# TECHNICAL NOTE

| Project     | Site A Willow Way, Sydenham                  |                           | Project No. | 22/089  |             |
| Subject     | Technical Note in Support of Planning Appeal |                           | Document No | TN004   |             |

**Table 1-1: LBL Officer Report Comments on the Application and VTP Response**

SWEPT PATH ANALYSIS OF WILLOW WAY DEMONSTRATING SERVICING BY MULTIPLE SITES

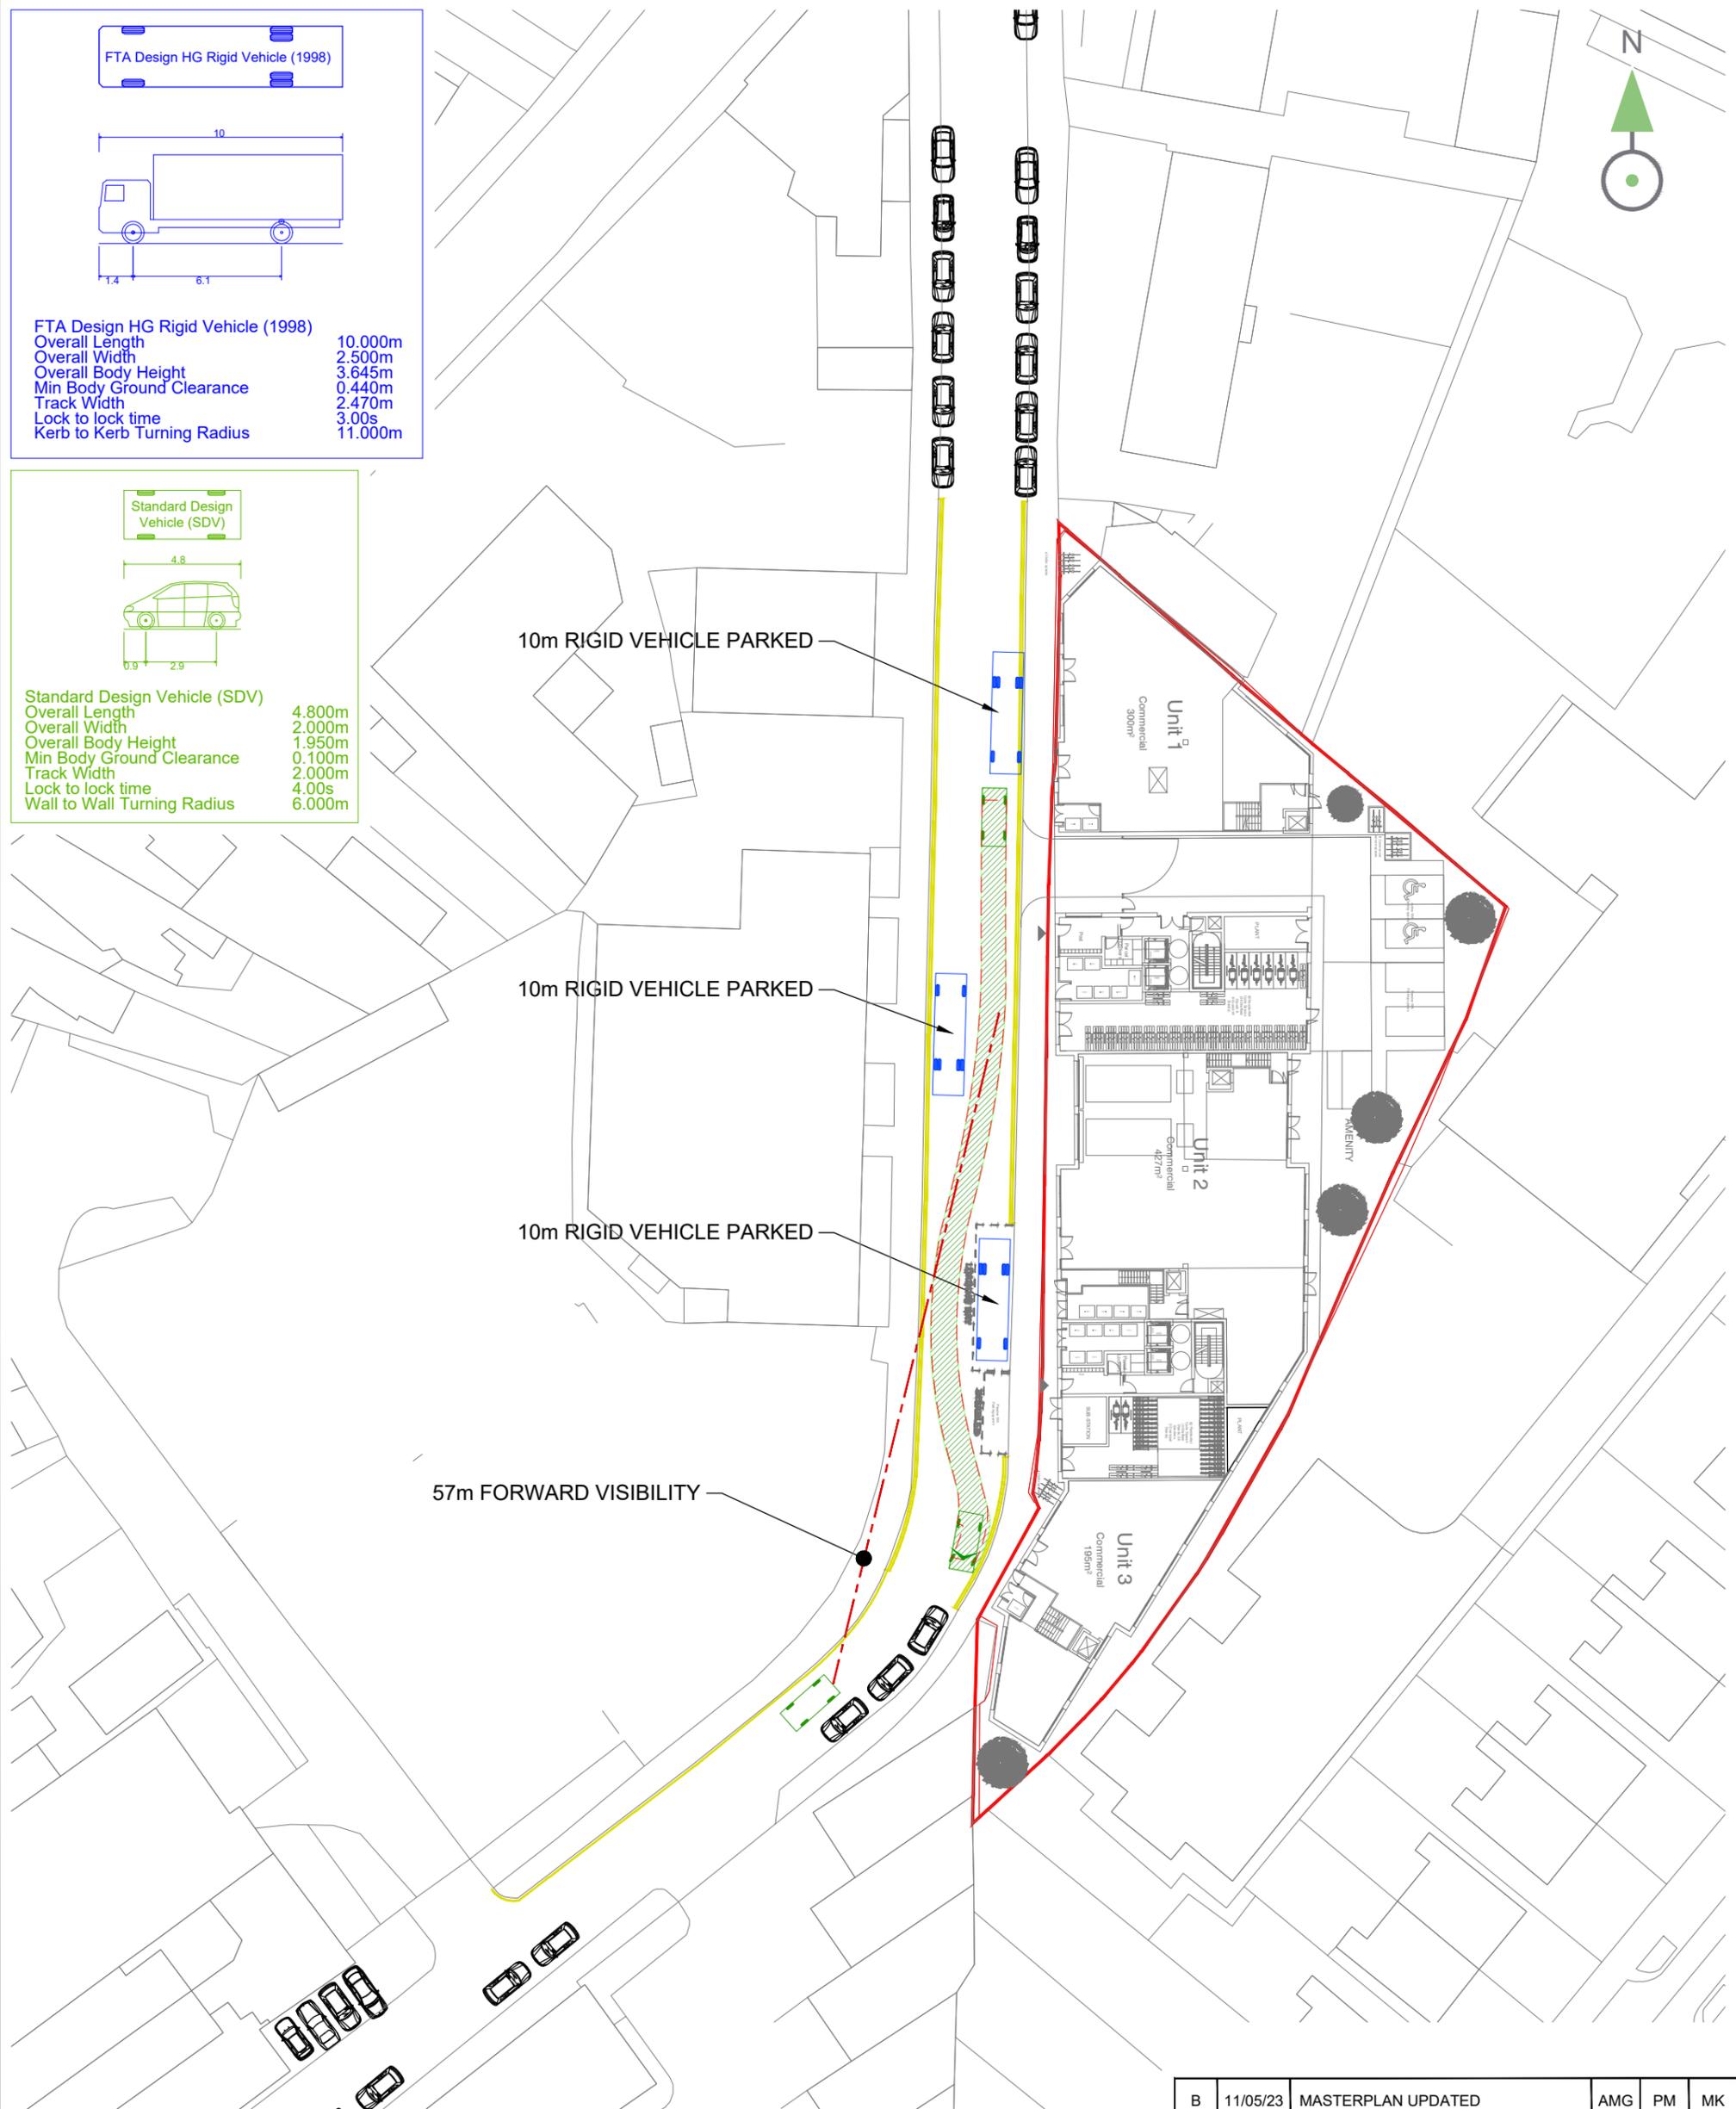
| PARAGRAPH | PLANNING OFFICER / LBL HIGHWAYS COMMENT  | VTP RESPONSE  |
|-----------|--|---|
| 308       | <p><b>Servicing Demand:</b><br/>The Highways officer has provided the following comments: There are concerns with regards to the proposed on-street loading strategy and if this is sufficient to accommodate all associated trips. The loading bay will only be able to accommodate one 10m ‘box van’ type vehicle at any one time, or it will only be able to accommodate 2 ‘standard’ sized vehicles at any one time.</p> <p>There are concerns with service and delivery vehicles having to park elsewhere along Willow Way when the loading bay is occupied.</p> <p>Further details will need be provided to evidence this loading bay is sufficient for the overall site including refuse collection.</p>  | <p>The proposed servicing demand has been demonstrated to be of a similar scale to the existing demand in the area and is likely to be accommodated easily within the proposed loading bay. Details of this arrangement have been set out within this Technical Note in response to paragraph 296-298 above.</p> <p>In the event that two 7.5t box van type vehicles propose to service the Site simultaneously, it may be necessary for one to stop on-street on Willow Way to unload. As it is proposed to provide double yellow lines along the frontage of the Site, which can be used for loading/unloading for a maximum of 40 minutes (as per section 5.18 of Lewisham Borough Council’s Parking Policy, March 2023), it is expected that there will be capacity on-street for vehicles to stop and undertake short term servicing, and that this will have no material impact on amenity on Willow Way.</p>   |

| PARAGRAPH | PLANNING OFFICER / LBL HIGHWAYS COMMENT   | VTP RESPONSE  |
|-----------|---|---|
|           | Highways would prefer servicing and delivery to be kept within the site where possible. If this is not possible the above concerns will need to be addressed in detail.   | <p>This arrangement will also provide a significant improvement compared to the existing situation in which, apart from some existing units along Willow Way having dedicated service yards, servicing must take place amongst existing cars that are parked on-street and that hinder access to the existing units.</p> <p>Refuse collection typically takes place early in the day when the frequency of deliveries will be low. Refuse collection is also most efficiently taken place by the Refuse Collection Vehicle (RCV) stopping in close proximity to each waste store, which is expected to be possible due to the double yellow lines restricting general parking. This is a standard arrangement, and it is not considered that there would be any hinderance to the refuse collection activities associated with the units to be serviced from Willow Way. See <b>APPENDIX C</b>.</p>       |

PLANS DEMONSTRATING REFUSE CARRY AND DRAG DISTANCES

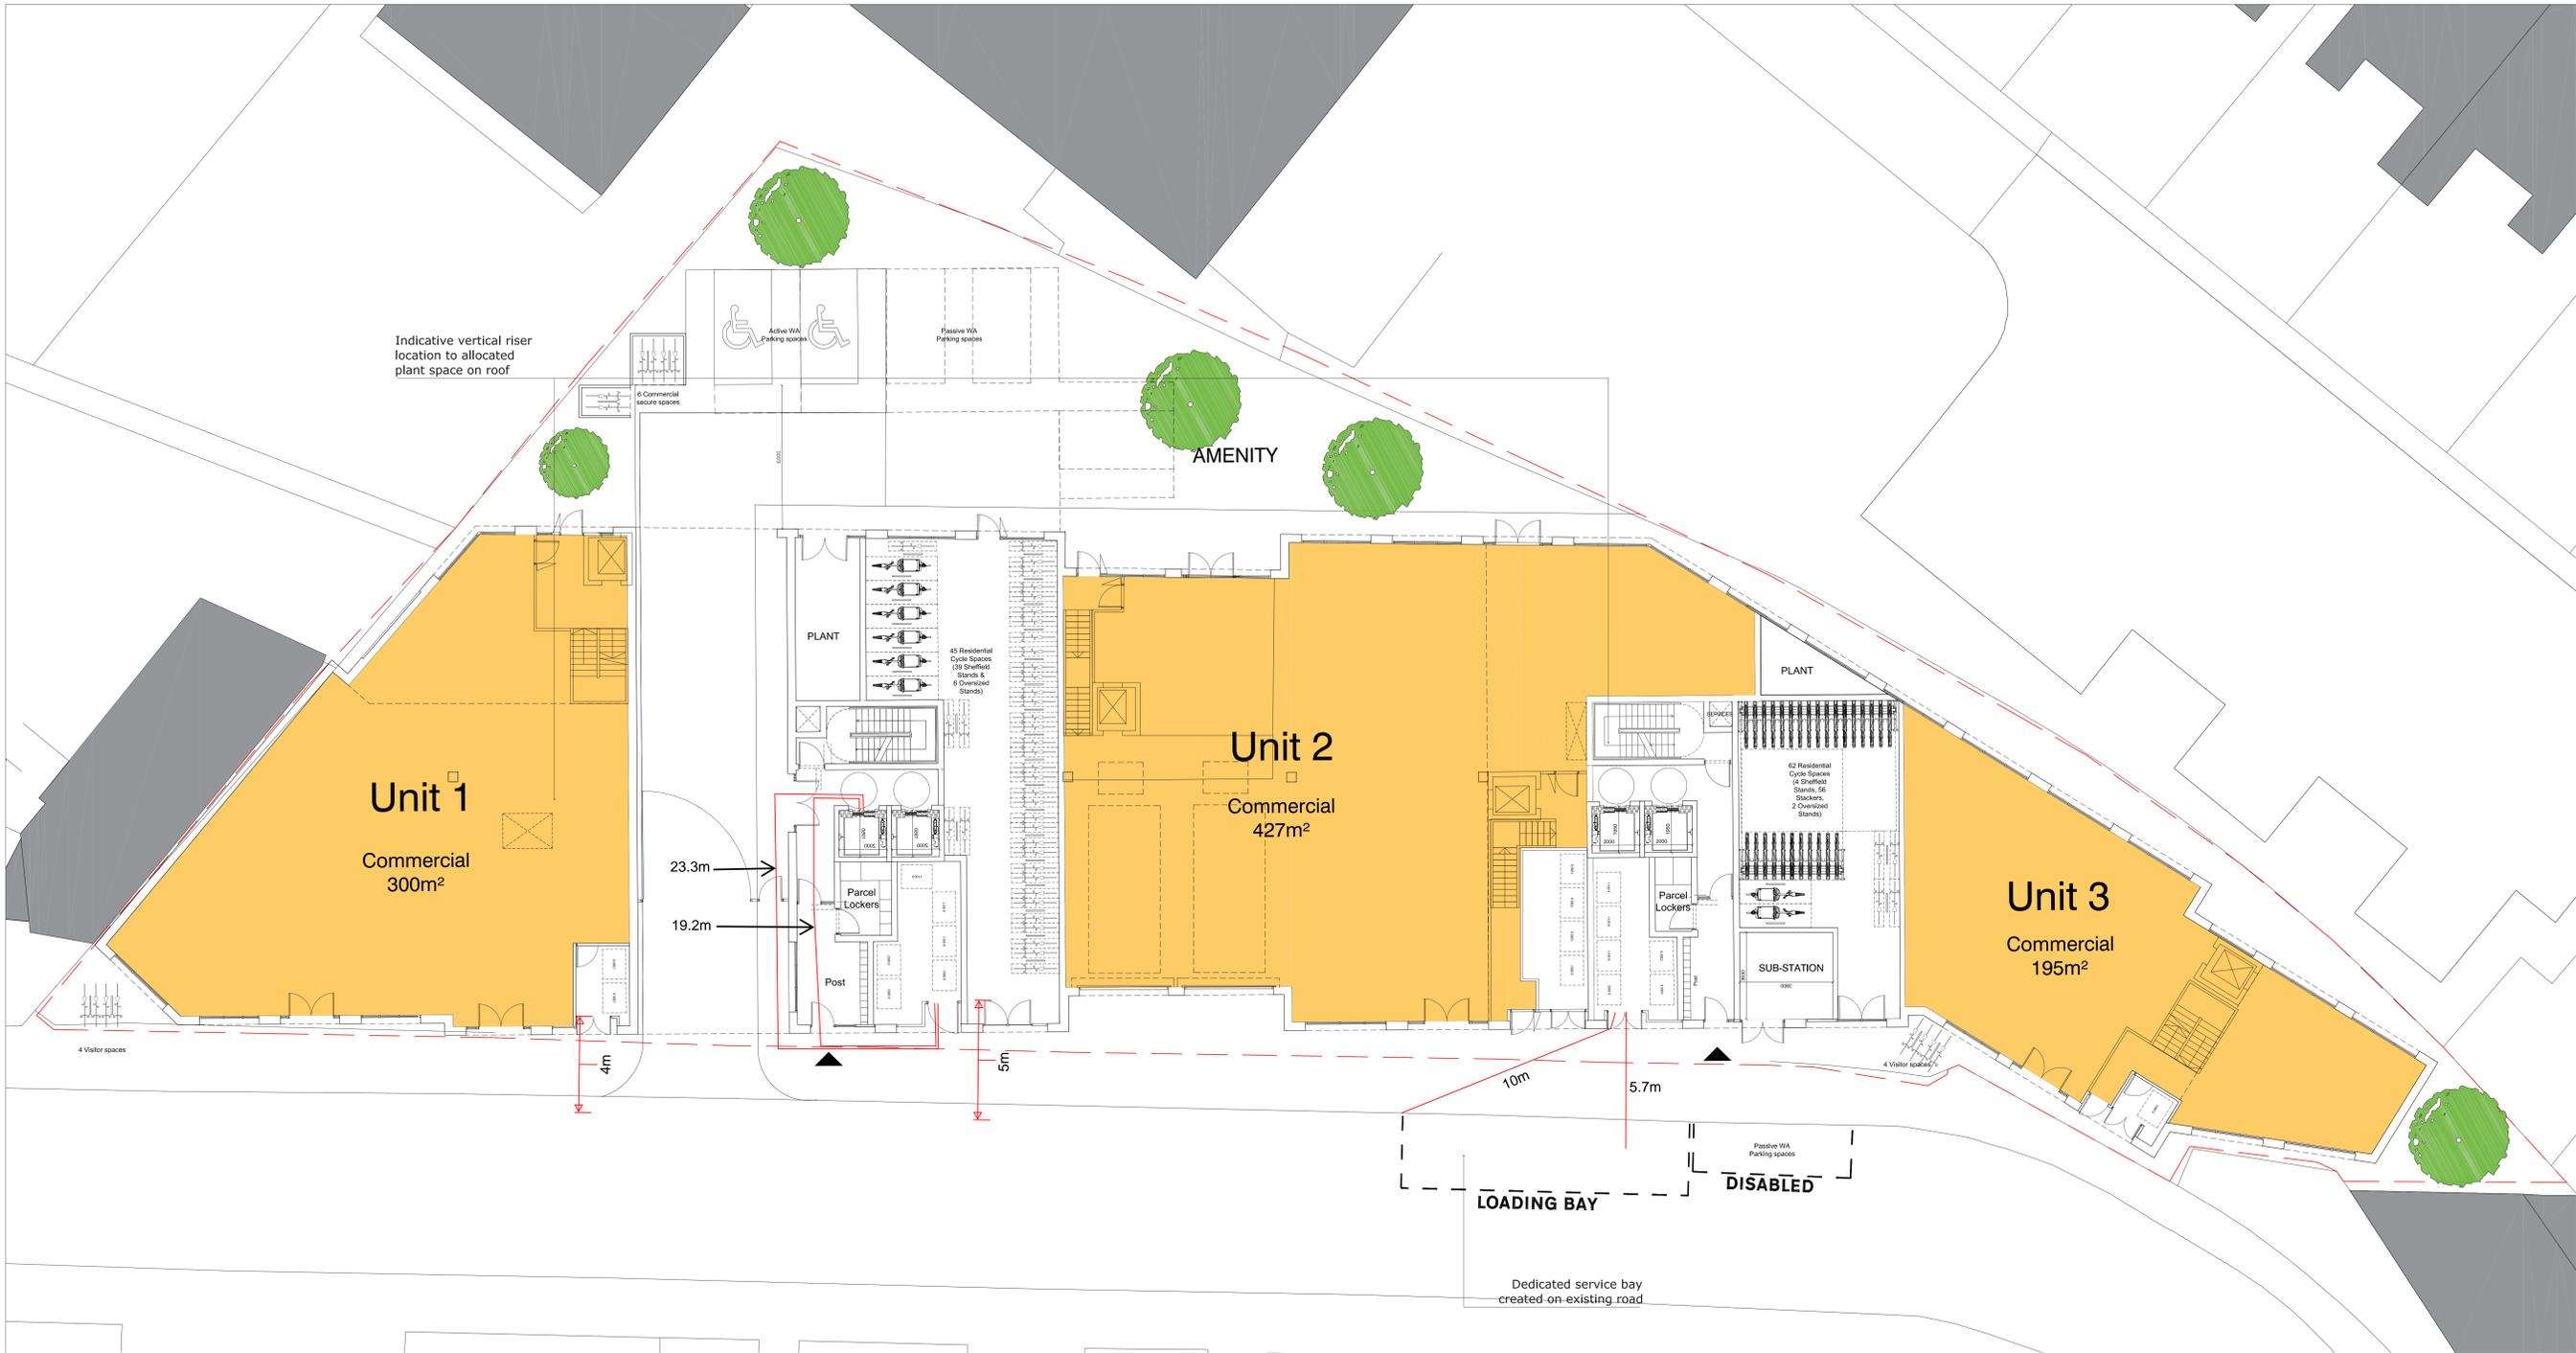
| PARAGRAPH | PLANNING OFFICER / LBL HIGHWAYS COMMENT   | VTP RESPONSE  |
|-----------|---|---|
| 309       | <p><b>Refuse Management:</b><br/>Refuse officers should also be consulted with regards to the size and location of the bin store. It should be reminded that residents are not permitted to carry refuse bins more than 30m to the bin collection point and waste operatives are restricted to a maximum 10m drag distance on collecting bins. It is suggested that a more detailed refuse strategy at this stage is presented to show the proposals adhere to the above requirements. Once approved this should be secured by condition.</p> | <p>The location of the refuse stores has been optimised as much as possible to minimise drag distances within the site's constraints. Whilst additional doors to the refuse stores would likely achieve the 30m carry distance, this would introduce unacceptable fire risks for the units.</p> <p>As shown on the drawings in <b>APPENDIX D</b>, only 11 of the total of 60 flats exceed the 30m drag distance to the refuse stores, which the average level of exceedance being just 3.3m over the permitted 30m, and a maximum of 36.5m. The impact of this slight exceedance is considered to be immaterial and is unlikely to be noticed by residents.</p> <p>RCV's typically stop on-street close to refuse stores to minimise drag distances, and the drawing in <b>APPENDIX D</b> demonstrates that drag distances are likely to be less than the maximum 10m distance for all refuse stores.</p> |
